**STATE PROJECT NO.: 2020-148**  
**PIERCE COLLEGE PUYALLUP**  
**NEW STEM BUILDING**  
 1601 39th AVE SE  
 Puyallup, WA 98374

Revisions		
#	Date	Description
1	08/19/2022	PERMIT RESUBMITTAL

TESC AND DEMOLITION PLAN

**C2.1**

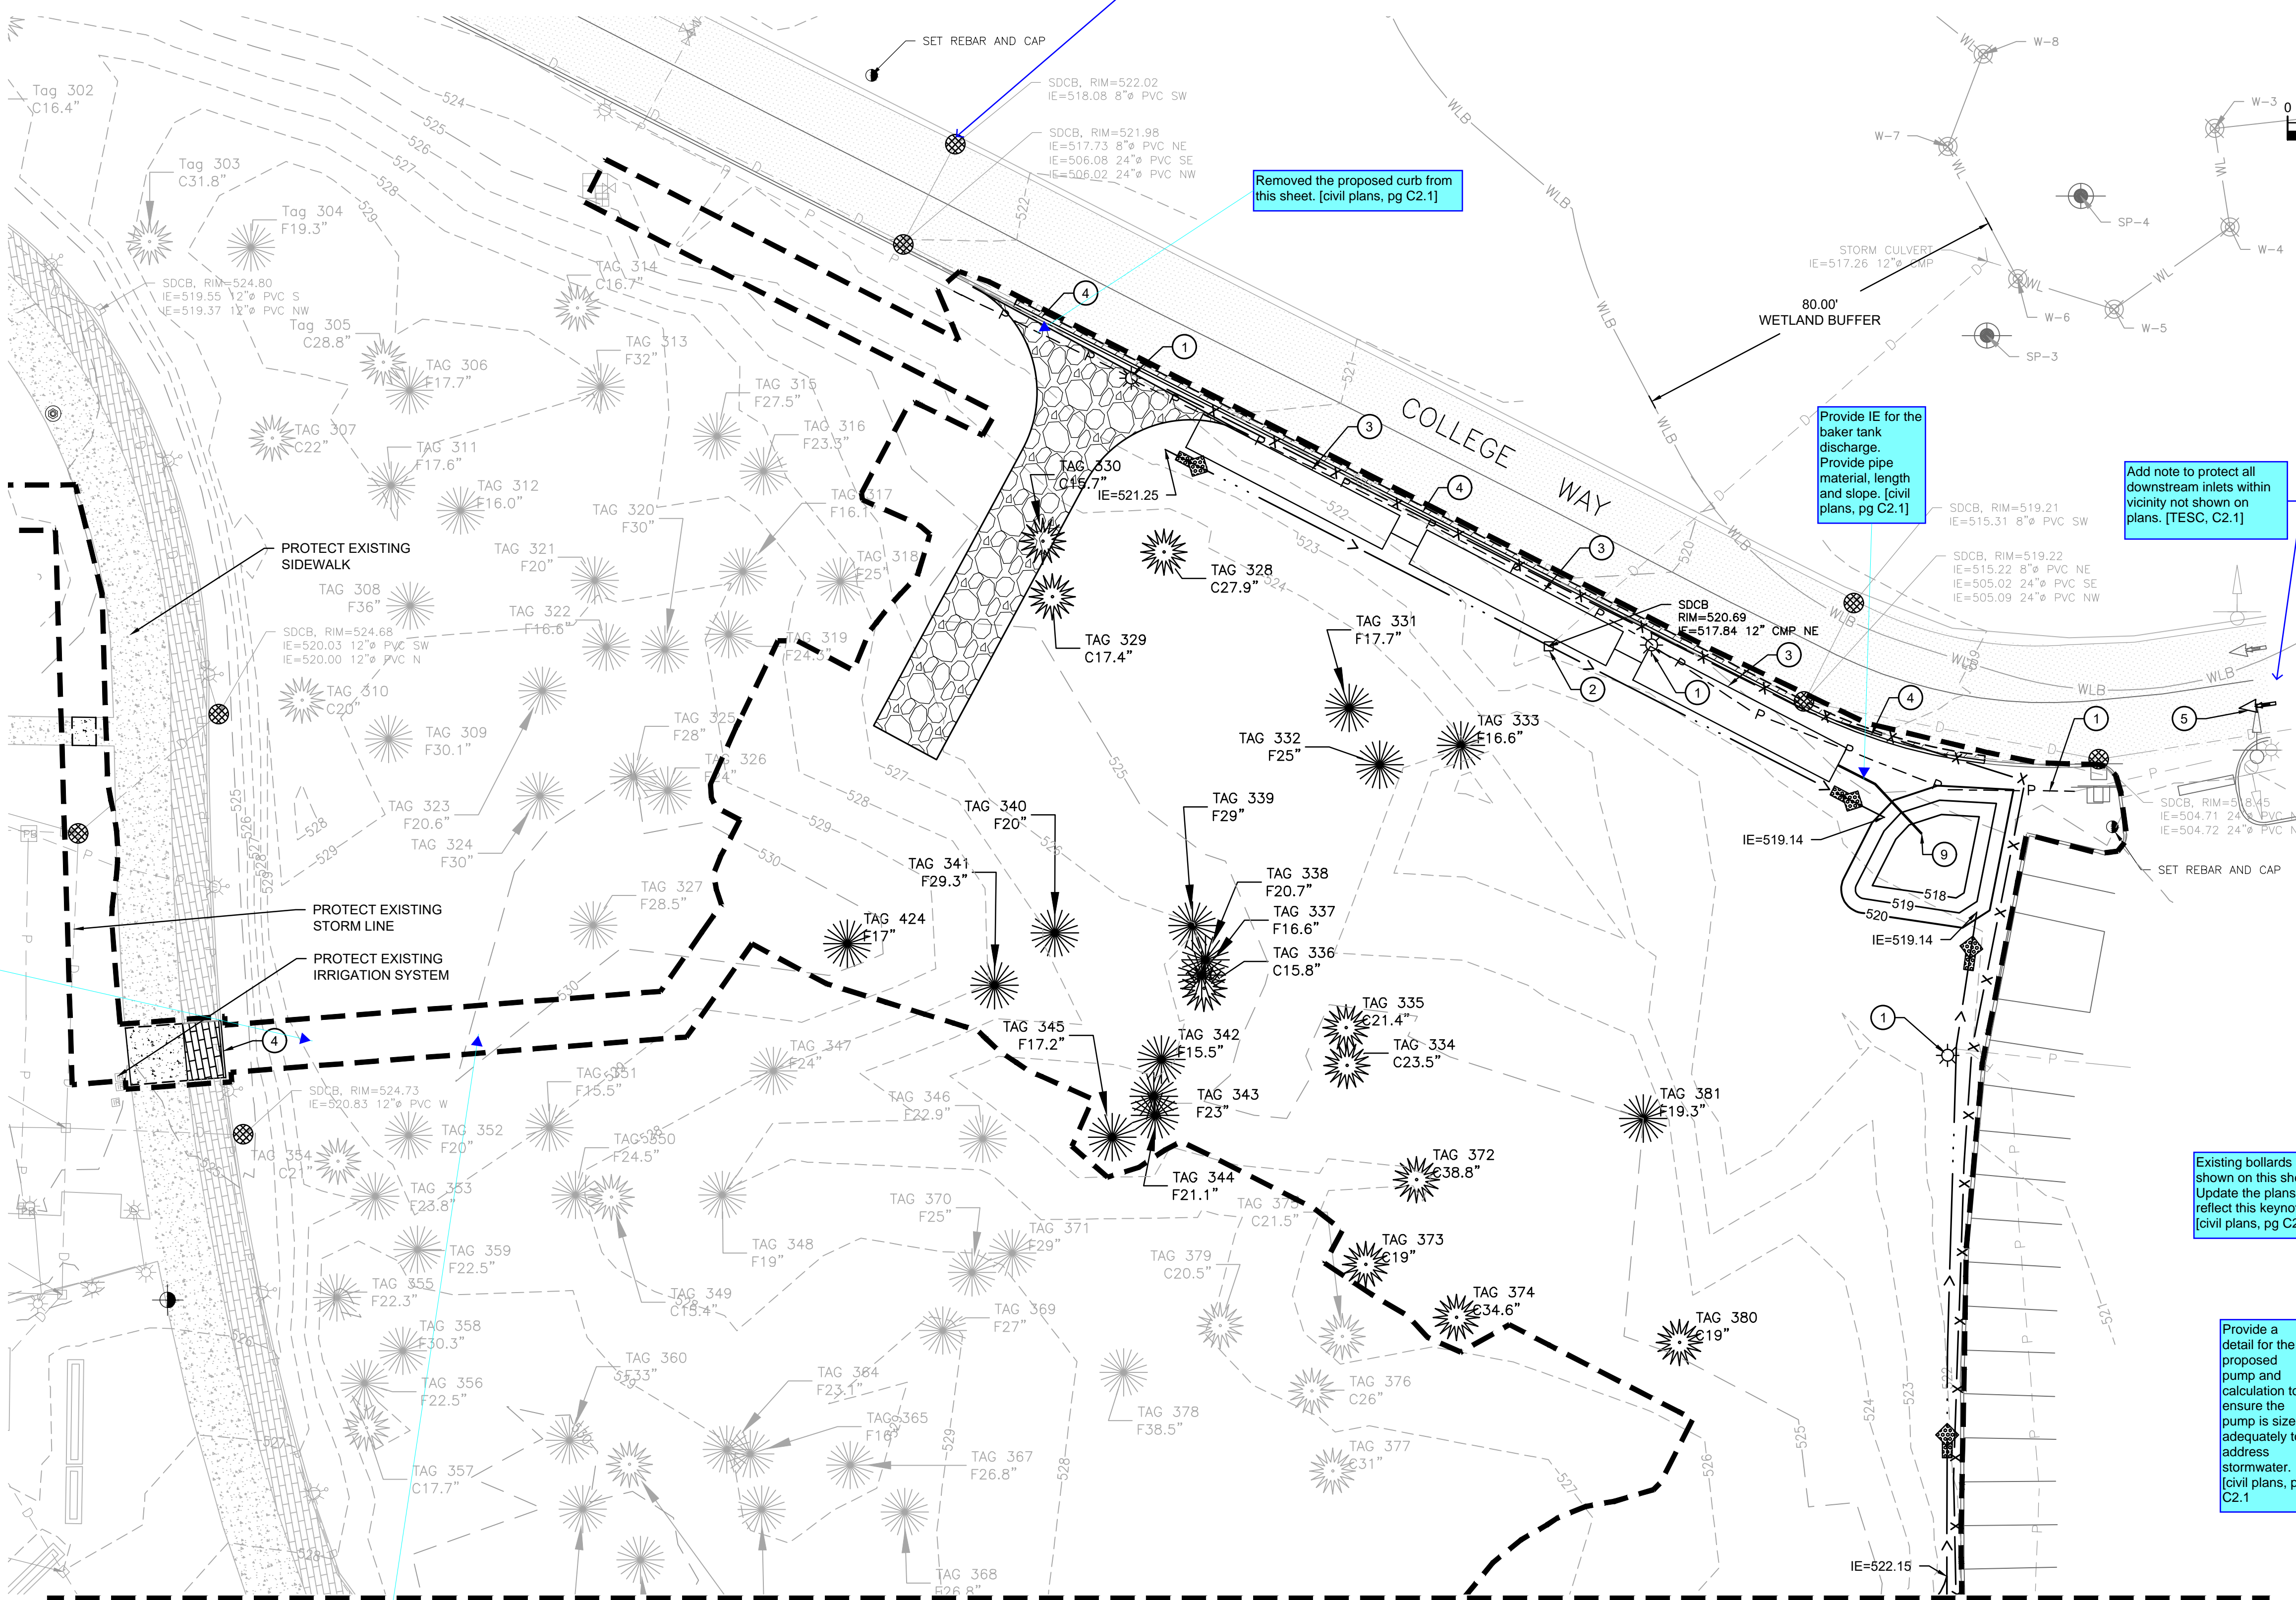
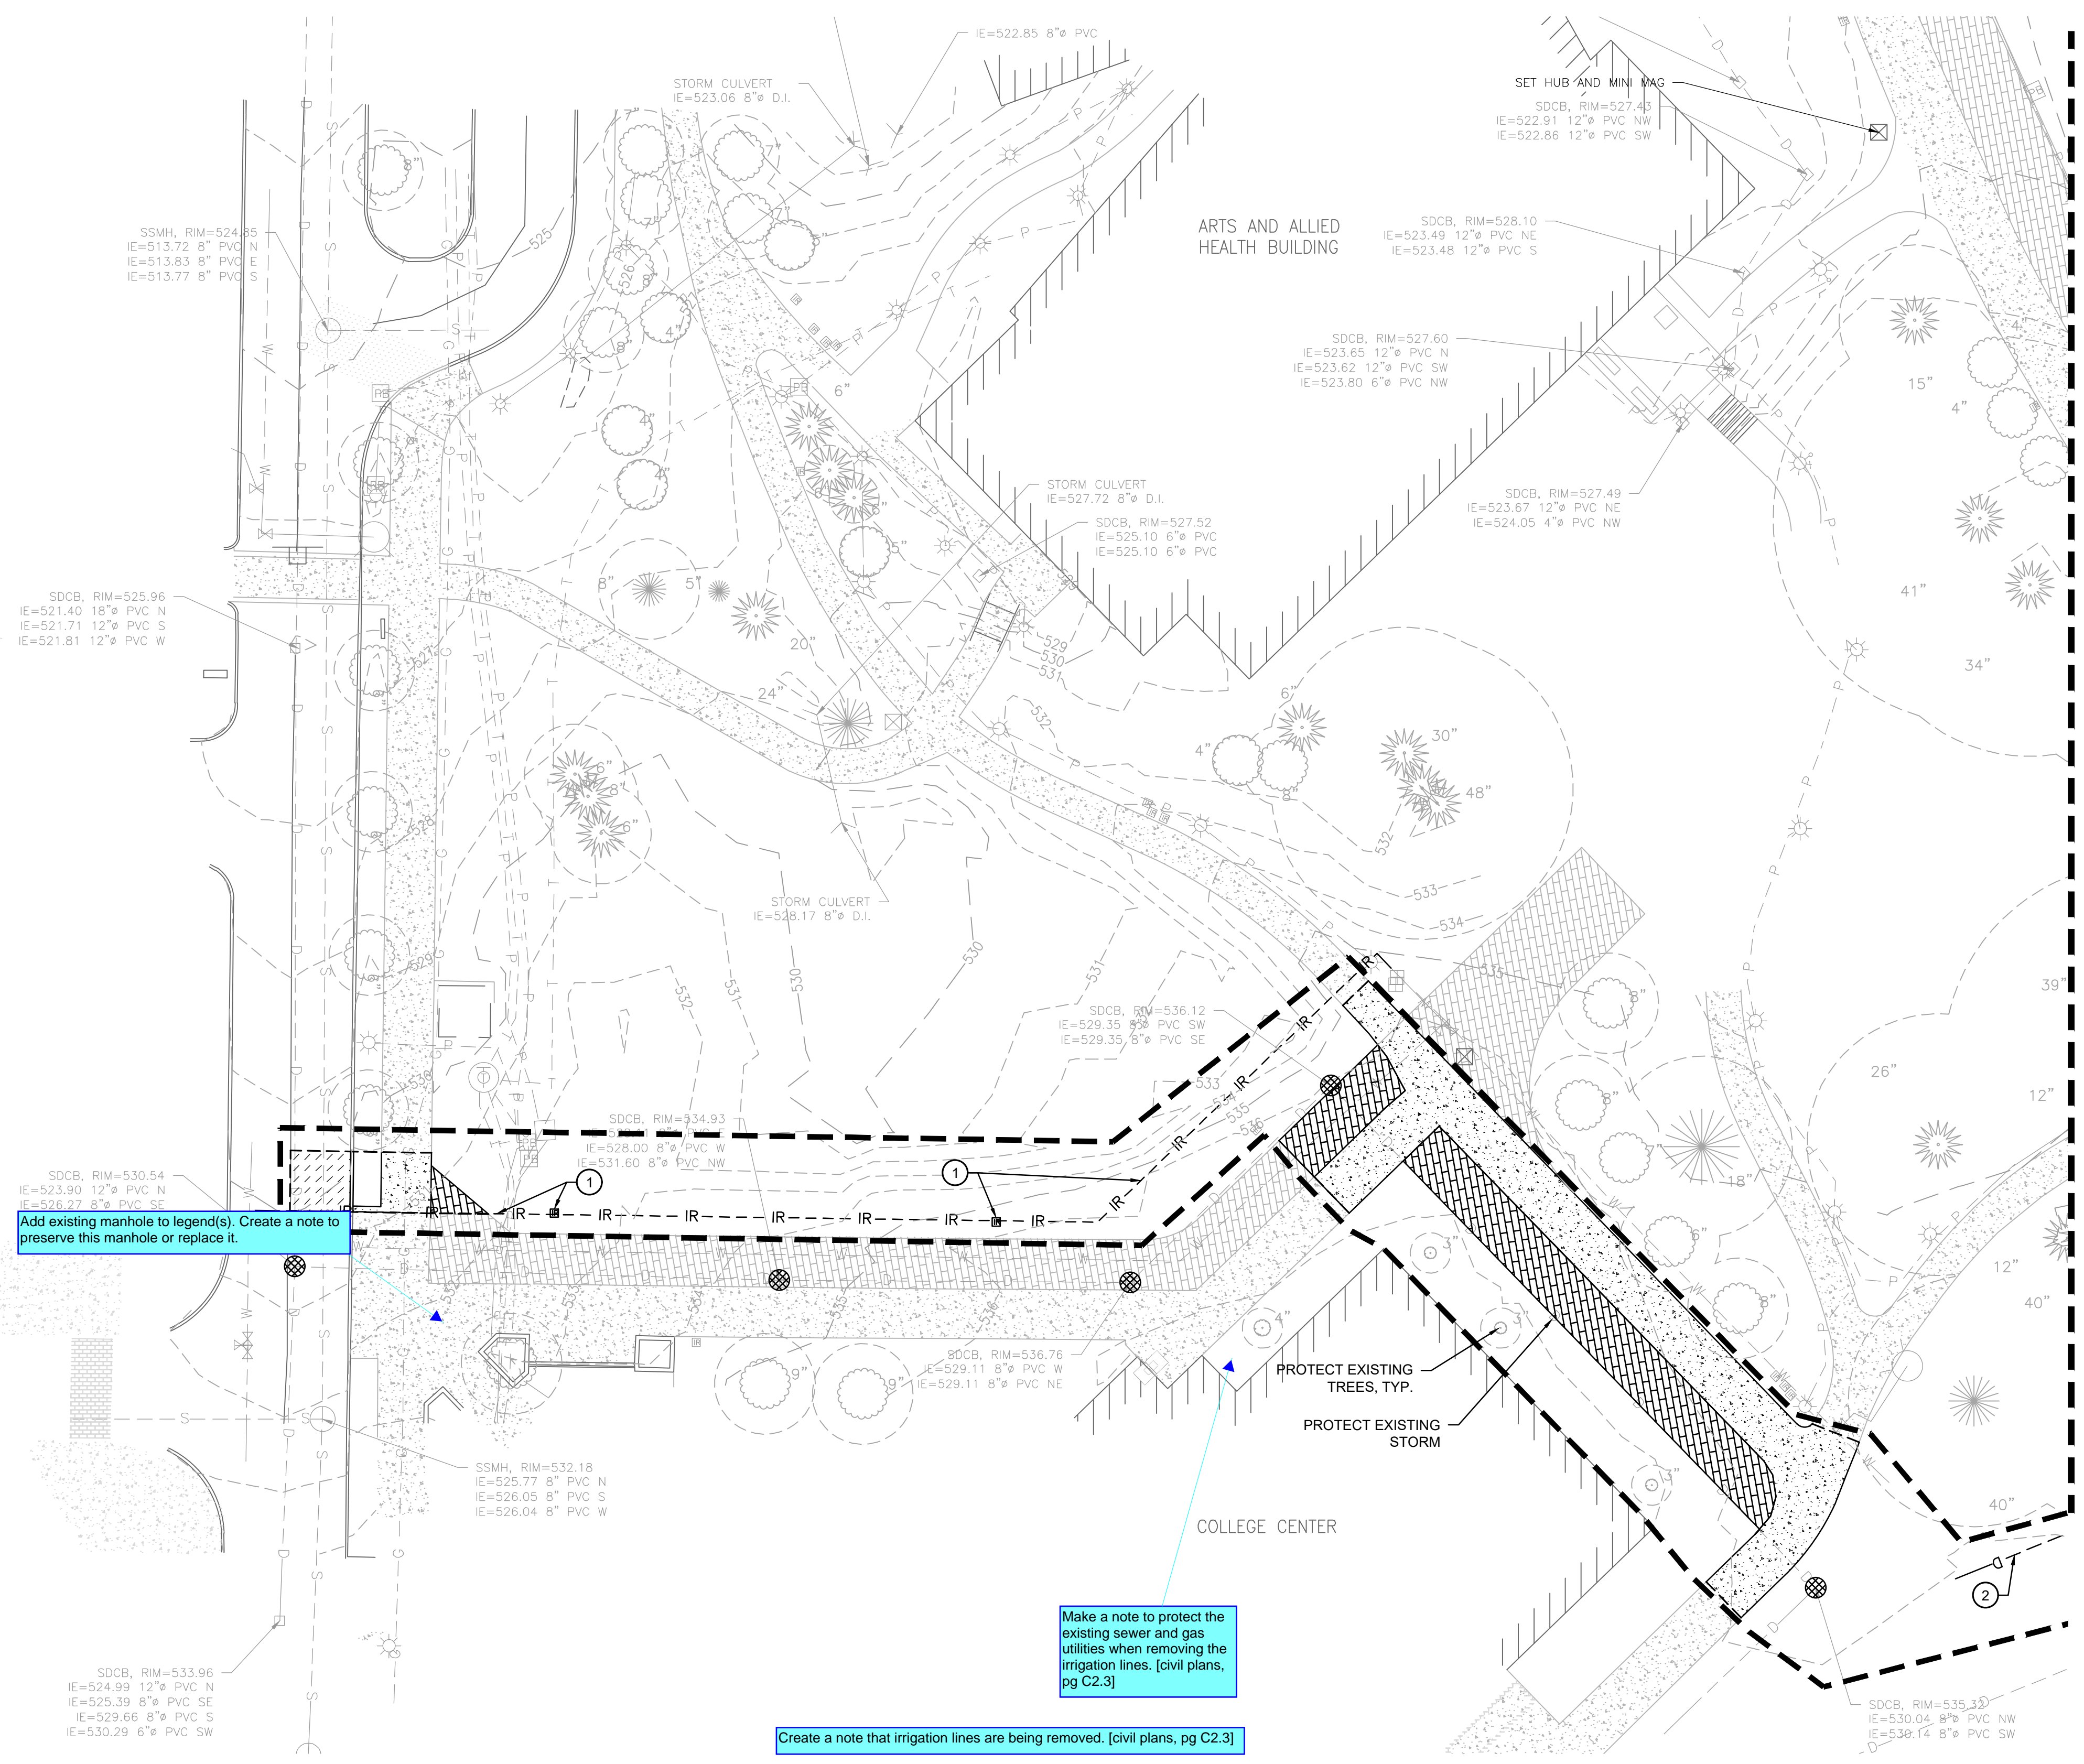
Remove the proposed landscape islands from the Tesc and demo plan [civil plans, pg C2.1]

Adjacent inlets still subject to sedimentation from potential track runoff. Protect all inlets in vicinity of work [TESC, C2.1]

Removed the proposed curb from this sheet. [civil plans, pg C2.1]

Provide IE for the baker tank discharge. Provide pipe material, length and slope. [civil plans, pg C2.1]

Add note to protect all downstream inlets within vicinity not shown on plans. [TESC, C2.1]

Revise text overlap. [civil plans, pg C2.1]

Proposed power? Remove from this sheet as it is not applicable to the Tesc and Demo plan. [civil plans, pg C2.1]

Provide a note to amend all disturbed soils per CS 01.02.08a [civil plans, pg C2.1]

**LEGEND:** Make a reference and provide a detail for the high visibility plastic or metal fence per BMP C103 as referred by the CSWPP. [E&S, pg C2.1]

Existing bollards not shown on this sheet. Update the plans to reflect this keynote. [civil plans, pg C2.1]

Provide a detail for the proposed pump and calculation to ensure the pump is sized adequately to address stormwater. [civil plans, pg C2.1]

Provide a detail for the proposed baker tank, be sure to include the dimensions. [civil plans, pg C2.1]

**C2.3**

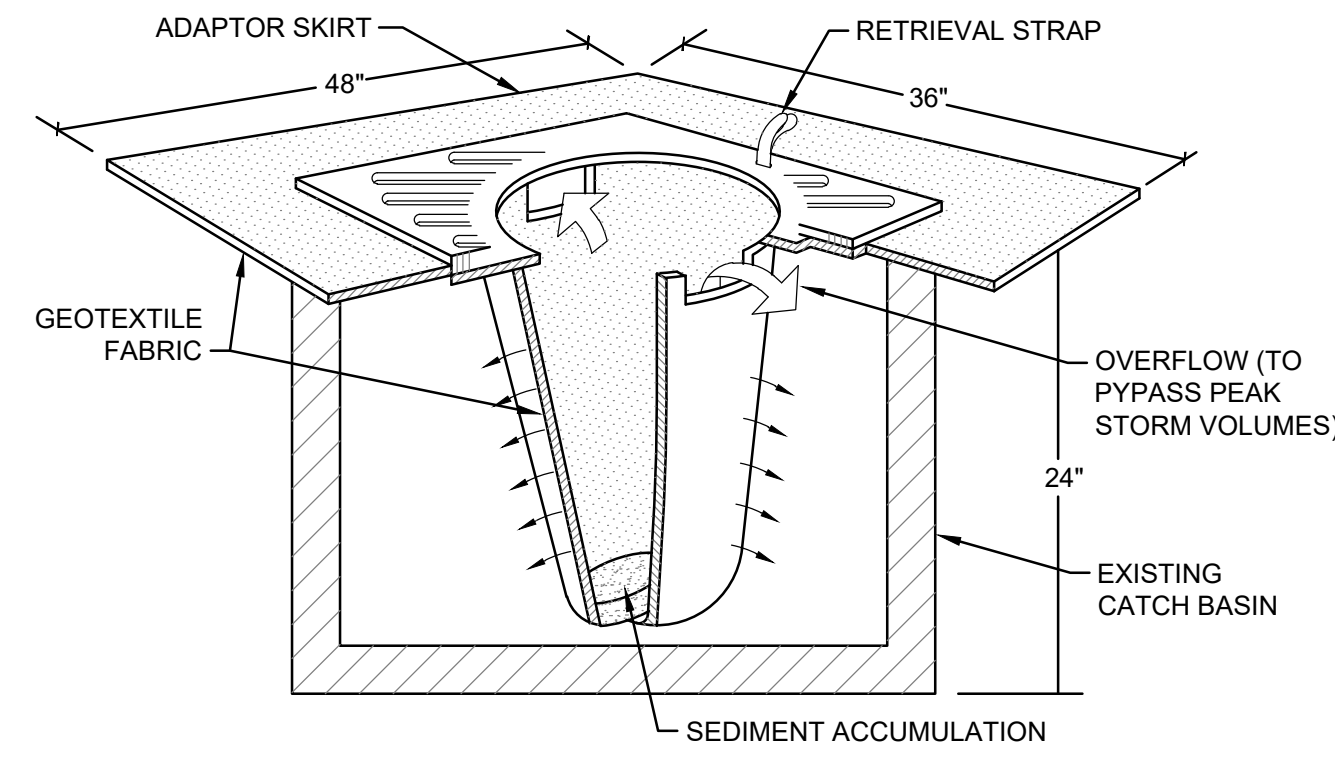
Add existing manhole to legend(s). Create a note to preserve this manhole or replace it.

Make a note to protect the existing sewer and gas utilities when removing the irrigation lines. [civil plans, pg C2.3]

Create a note that irrigation lines are being removed. [civil plans, pg C2.3]

Remove keynotes not applicable to this sheet. [civil plans, pg C2.3]
